Case Numbers:
ZA-2020-752-ZAD-ZAA-1A
3005 North Amethyst St.

ZA-2020-781-ZAD-ZAA-1A
3009 North Amethyst St.

Appellant presentation for hearing
East Los Angeles Area Planning Commission
5/11/2022

The project as shown in case drawings on the department of planning website uploaded 6/30/2021 does not conform to the following key aspects of applicable zoning code/ordinances.

SHEET NUMBER: A - 3.2

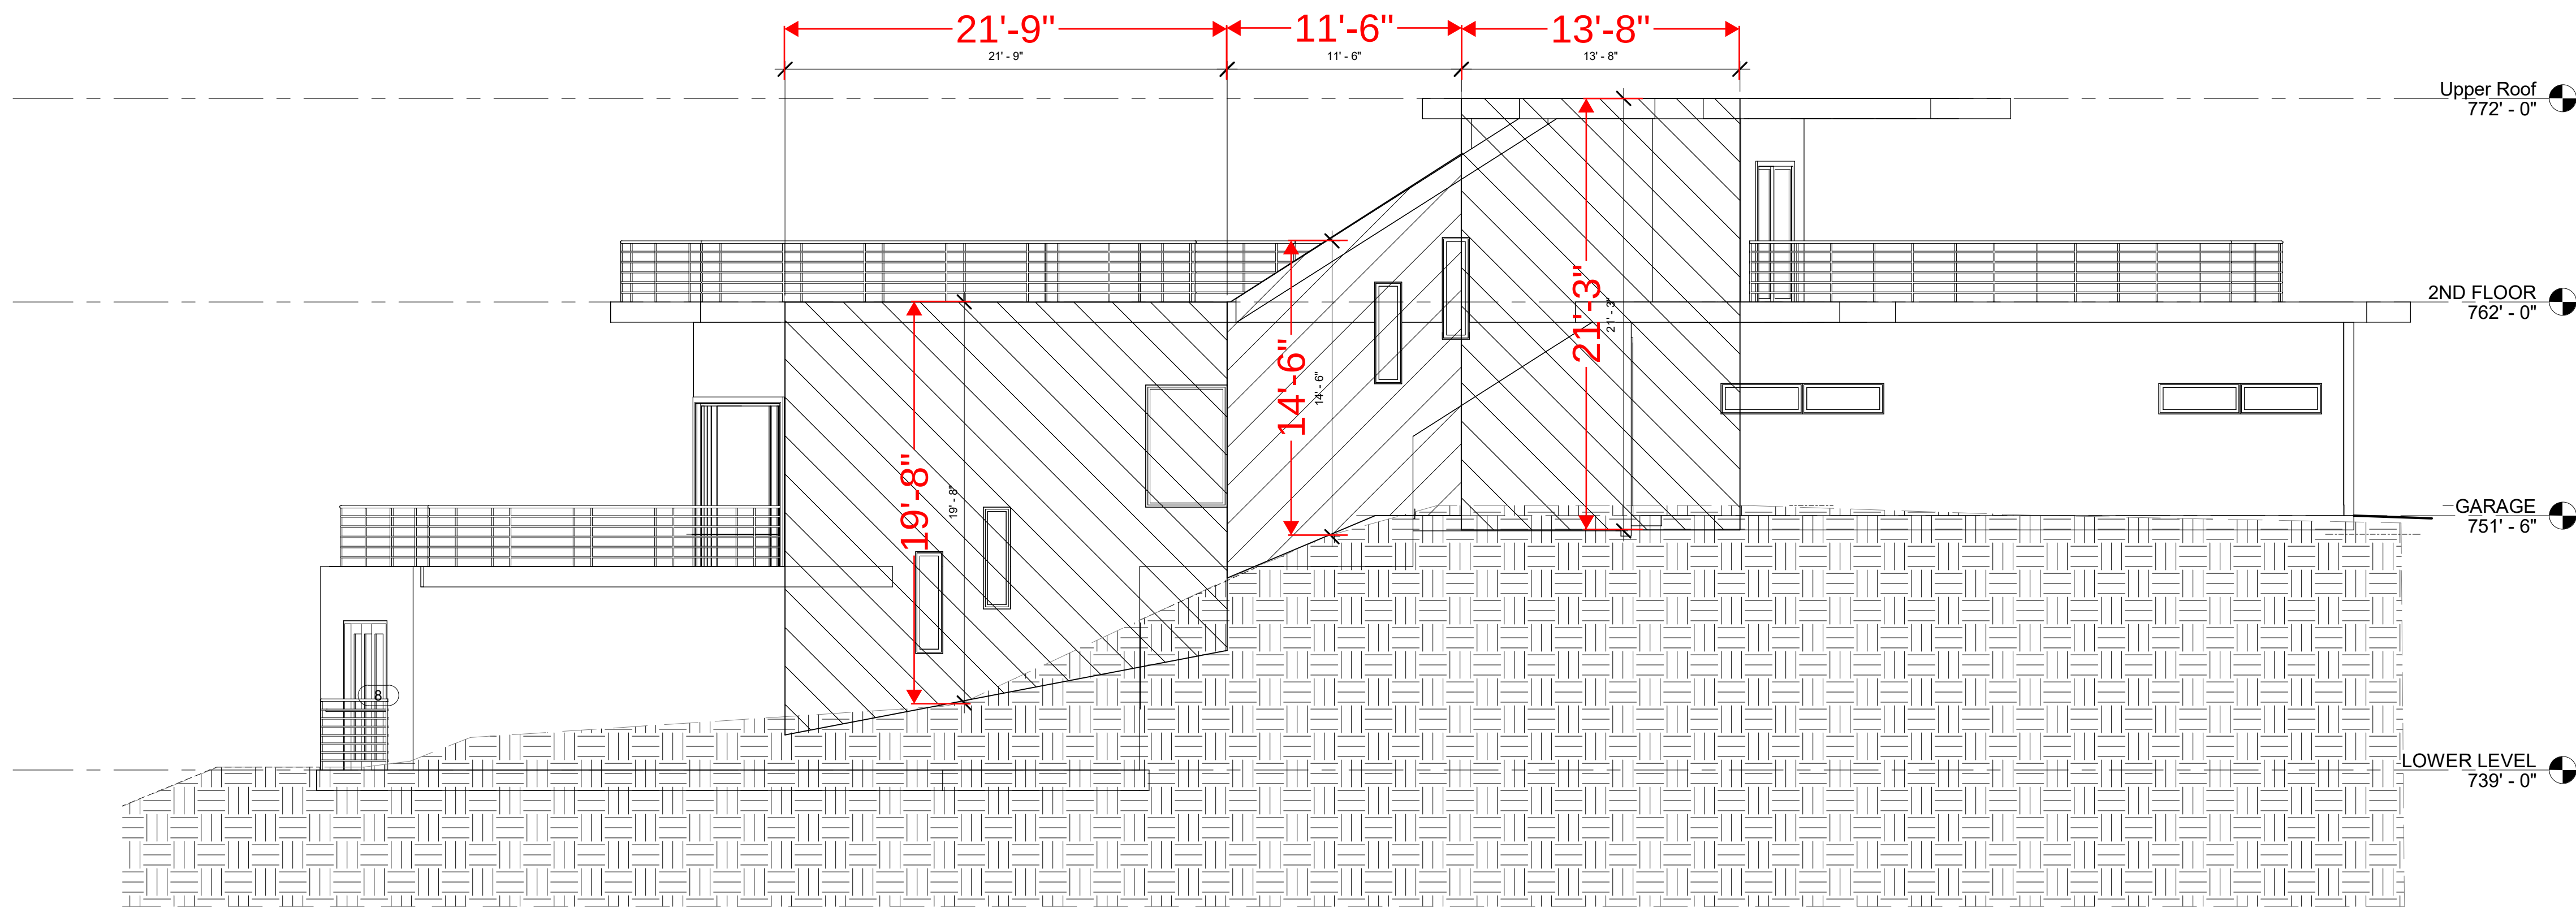
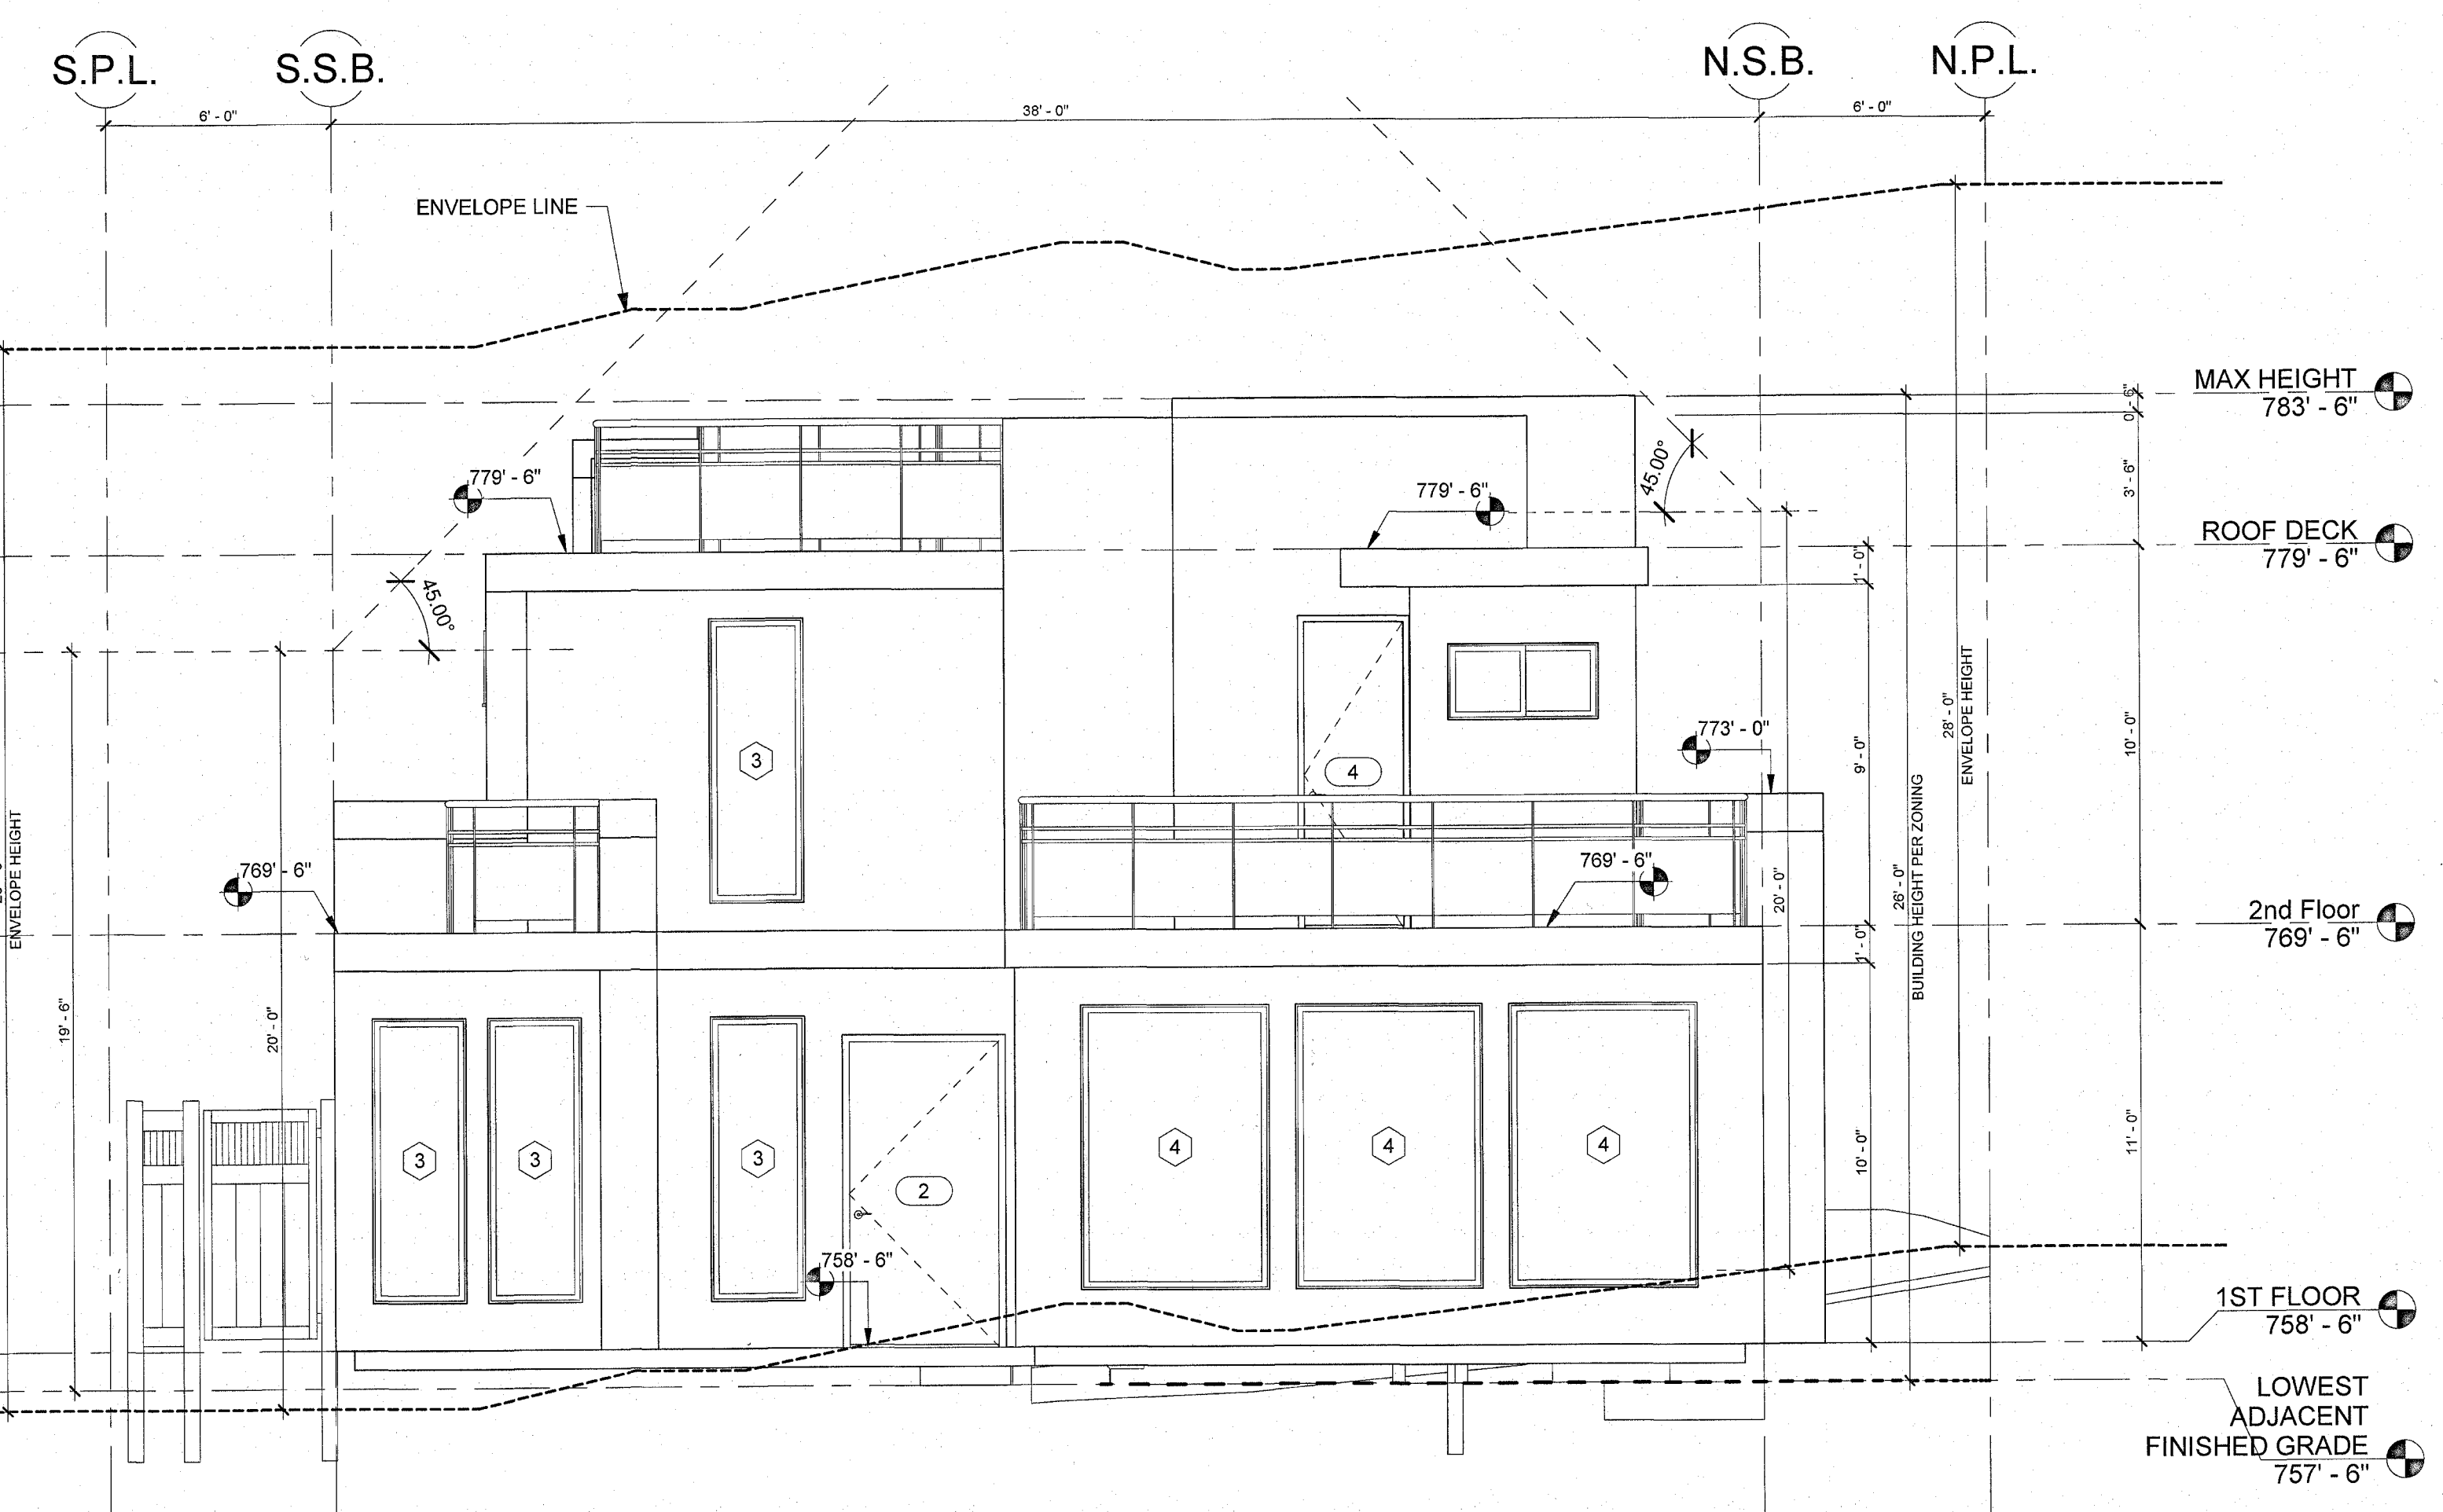
3. The project has side walls exceeding 14 feet in height and a continuous length greater than 45 feet without an offset/plane break that is a minimum depth of five feet beyond the required yard and a minimum length of 10 feet as required by 12.08.C.2.
